NOTICE OF DECISION

DECISION OF THE PLANNING ADMINISTRATOR

SUBDIVISION / CLASS 2 ADJUSTMENT CASE NO. SUB-ADJ17-09

REQUEST: A consolidated application for a 46-lot phased subdivision ("Dogwood Heights") containing the following requests:

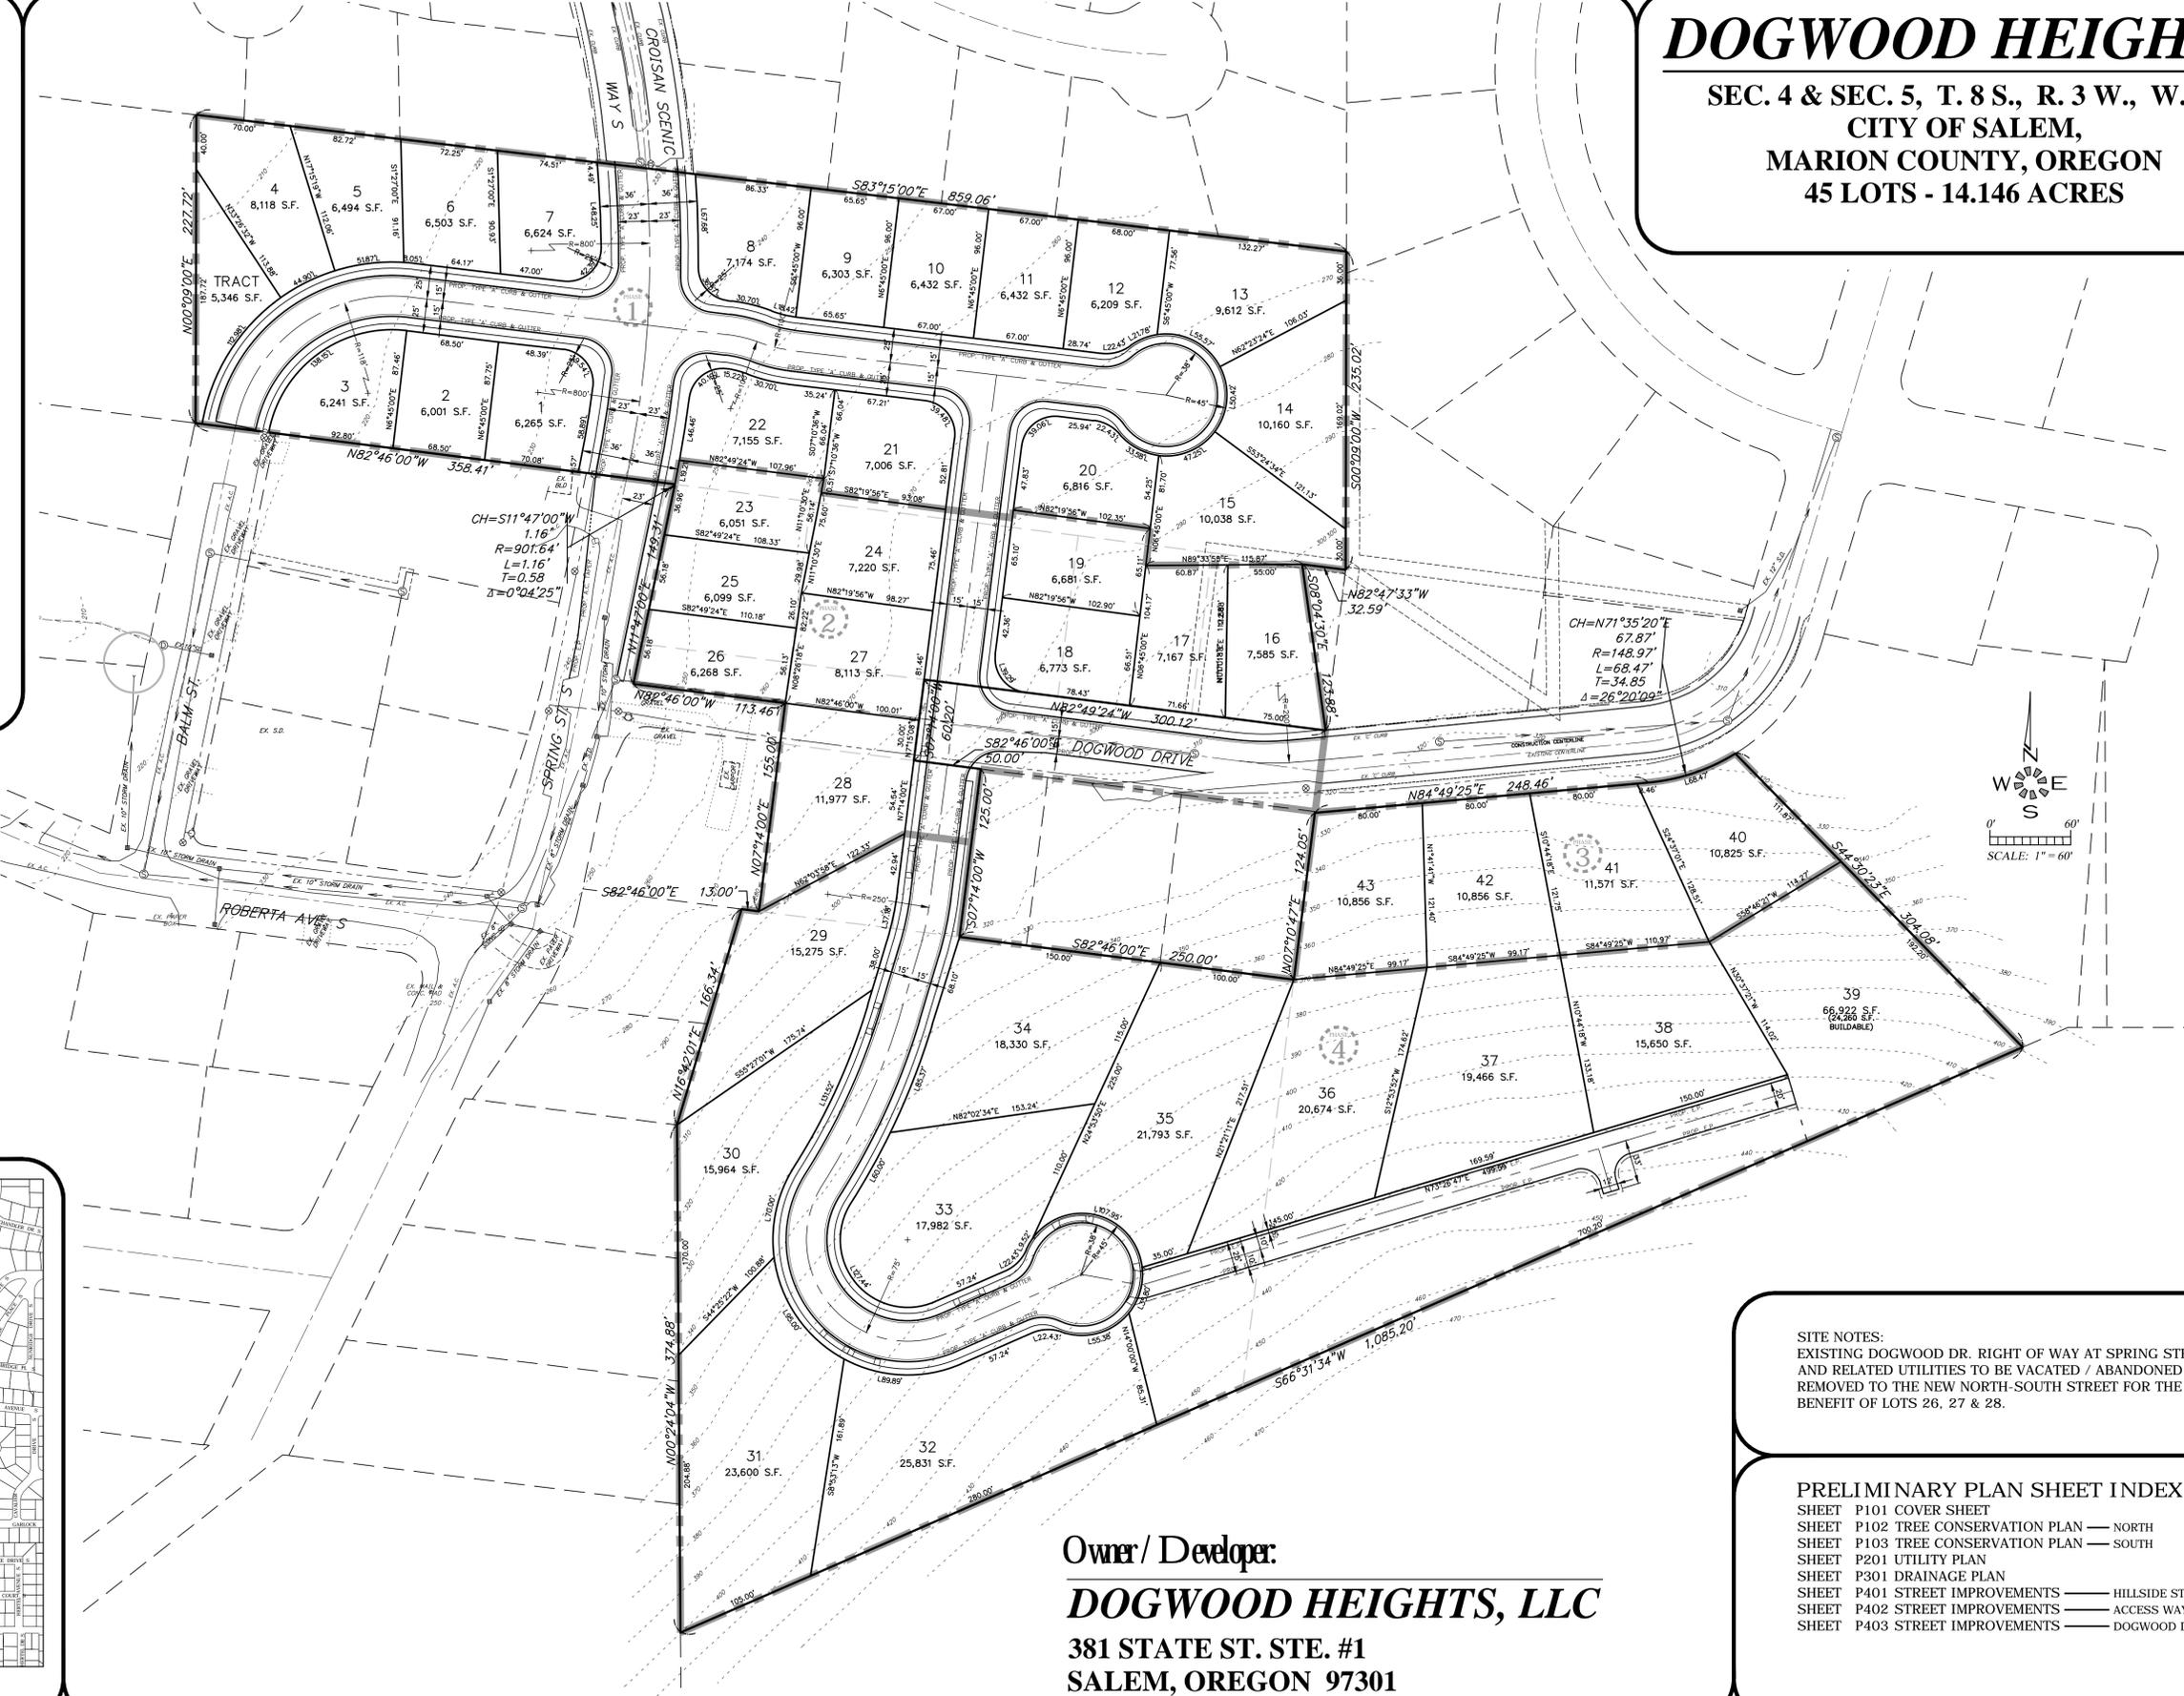
- 1) A phased subdivision tentative plan to divide approximately 14.14 acres into 46 lots as follows:
 - a) Phase 1 containing 20 lots ranging in size from 4,577 square feet to 11,169 square feet;
 - b) Phase 2 containing 11 lots ranging in size from 6,061 square feet to 6,939 square feet;
 - c) Phase 3 containing 4 lots ranging in size from 10,825 square feet to 11,571 square feet; and
 - d) Phase 4 containing 11 lots ranging in size from ~~17,982~~ 12,979 square feet to 34,793 square feet.
- 2) Class 2 Adjustments to:
 - a) Increase the maximum allowed grade of Hillside Court S, a local street, from 12 percent, as required under SRC 803.035(c), to 15 percent; and
 - b) Increase the maximum length of the flag lot accessway serving Lots 36-39 from 400 feet, as required pursuant to SRC 800.025(c), to 500 feet.

PRELIMINARY PLAN COVER SHEET

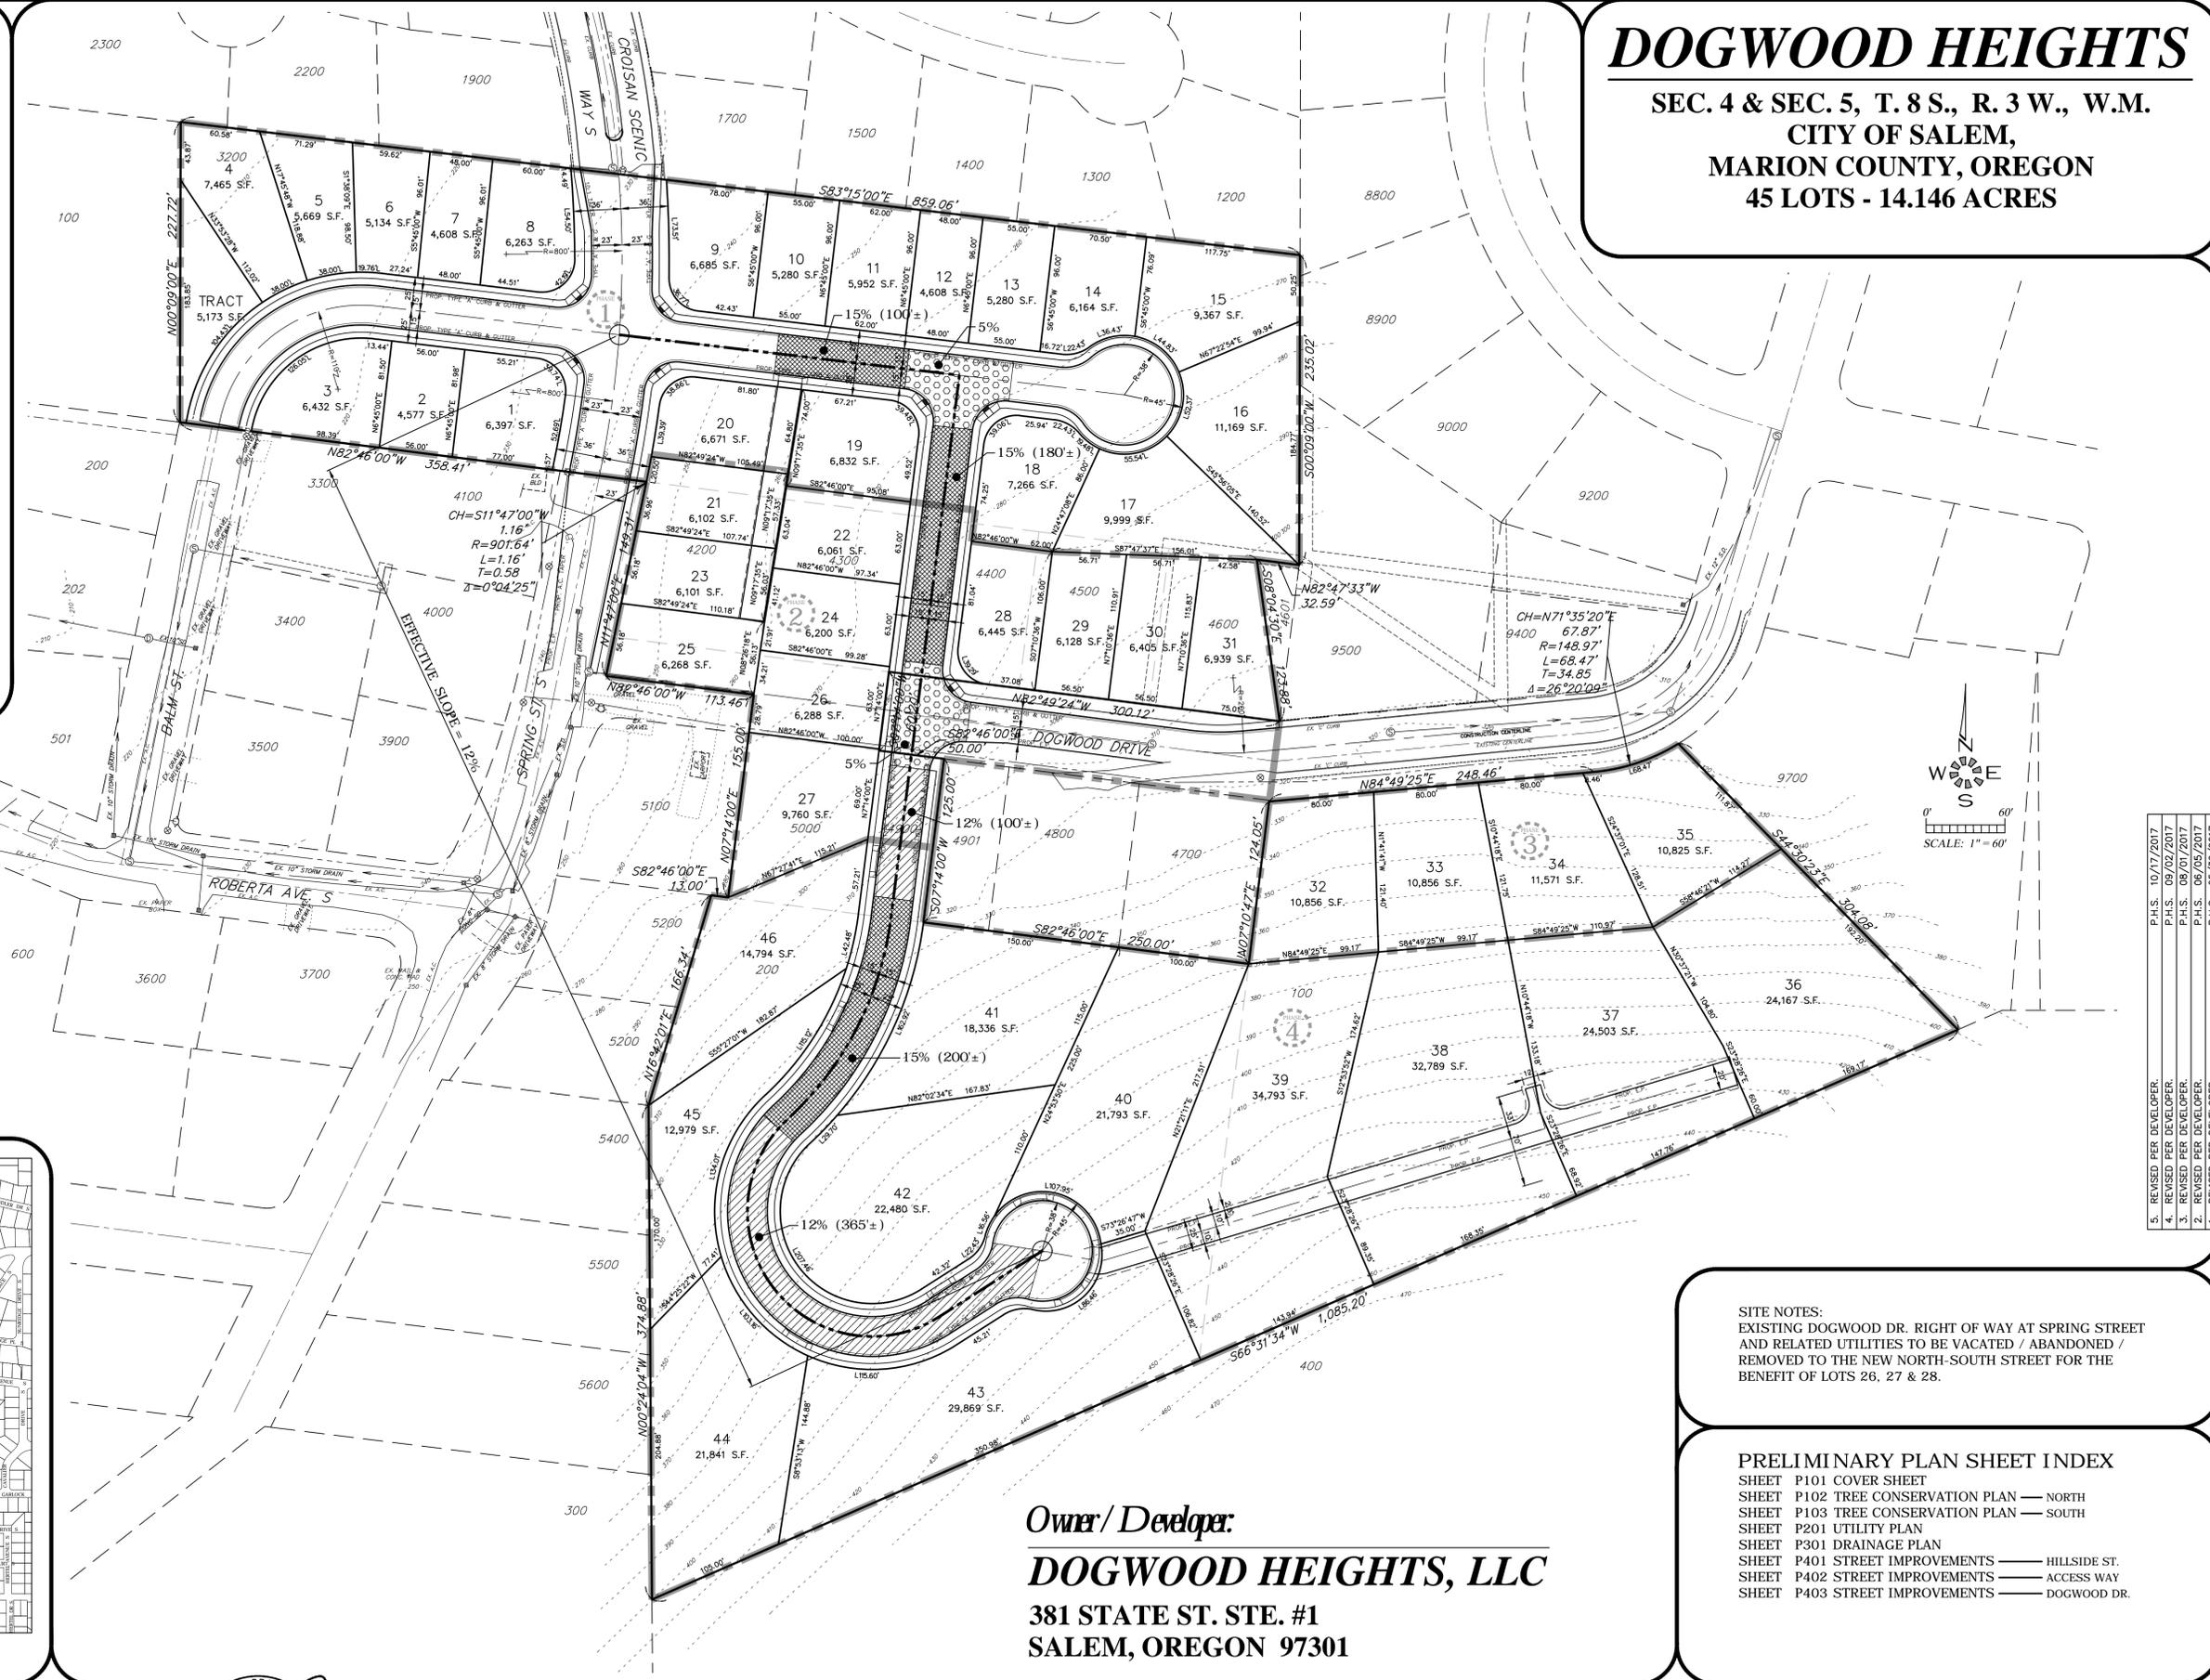
- Condition 18:** The final plat for each phase, including street grades, shall be in substantial conformance with the revised site plan submitted October 23, 2017 and included as Attachment C.
- Condition 19:** Prior to final plat approval of Phase 4, install no-parking signs along Hillside Court as specified by the Public Works Director.
- Condition 20:** Provide a fire apparatus turnout along the flag lot accessway serving Lots 36-39. The turnout shall be at least 10 feet in width and 40 feet in length and meet all design requirements set forth in the Salem Fire Prevention Code (Salem Revised Code Chapter 58).

Staff Response: The applicant has submitted a revised proposal for Hillside Court and adjacent local streets (Attachment C) which limits the segments of streets exceeding 12 percent grade to no more than 200 feet in length each. Each segment of steeper grades would be interrupted by segments of 12 percent or less grade, or intersections with 5 percent or less grade. As described in further detail in findings below on the requested
